**PACIFIC POWER • UTAH POWER**

ACT/015/018-91A
#2

May 16, 1991

**RE: DEFICIENCY RESPONSE, DRAINAGE AMENDMENT, PACIFICORP ELECTRIC OPERATIONS, DEER CREEK MINE, ACT/015/018**

FIGURE 3

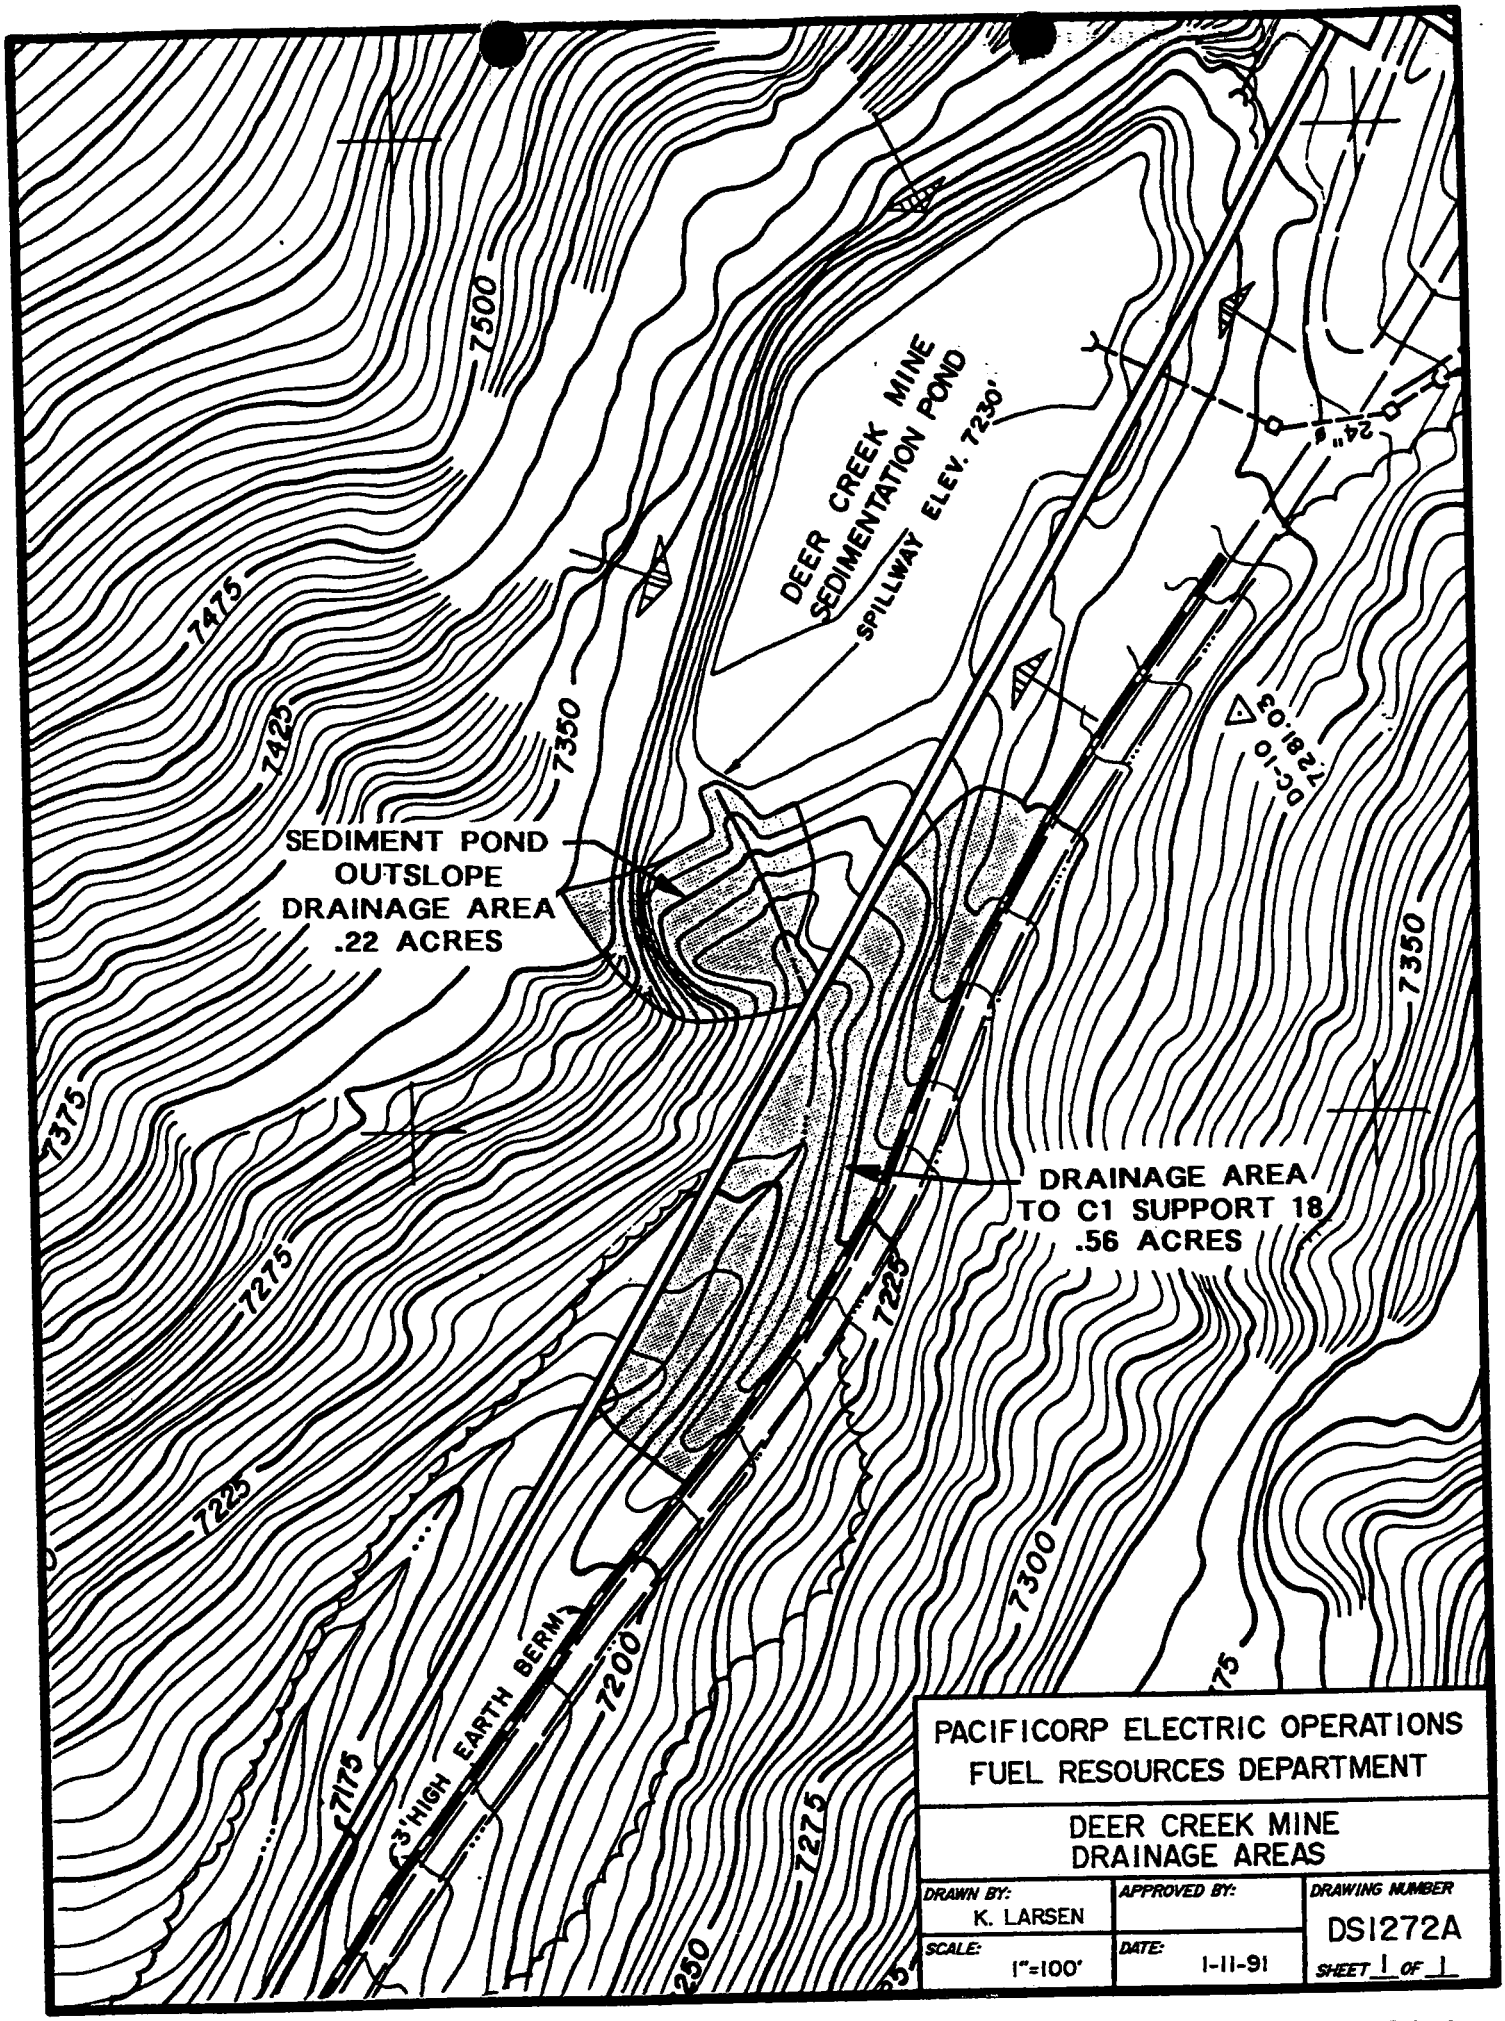
2) **A DRAINAGE MAP OF APPROPRIATE SCALE MUST BE PROVIDED OR REFERENCED TO SHOWING <u>TOTAL</u> DRAINAGE AREA. PLEASE NOTE: THAT THE 6' CULVERT IS JUST DOWNSTREAM OF THE SEDIMENT POND OUTLET AND SUBSEQUENTLY MUST PASS THE EXPECTED PEAK FLOW FROM THE SEDIMENT POND. PLEASE VERIFY THIS IN YOUR CALCULATIONS.**

Refer to Figure 6 of Appendix IX (1" = 2000') along with Figure 3 (1" = 100') for the total drainage area. Figure 3 is used because the small areas are difficult to see if added to Figure 6.

24.21
FIGURE 7

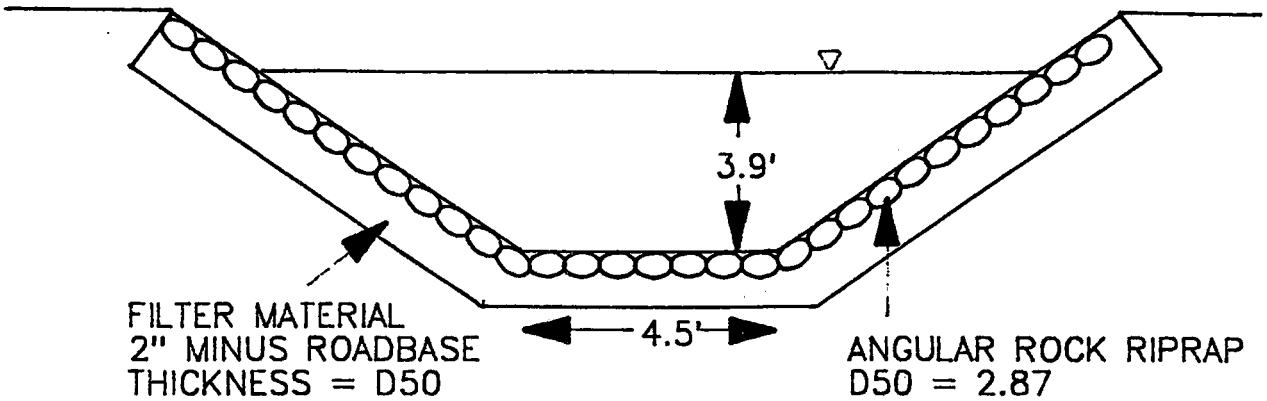
4) **REFERENCE TO CHANNEL RECLAMATION FOR THESE CULVERTS, IF APPROPRIATE, MUST BE DOCUMENTED.**

Reclamation channel information is found on Pages 24.4 and 24.15 - 24.24.

Designs for the reclaimed channel are found on Figures 7 through 8.
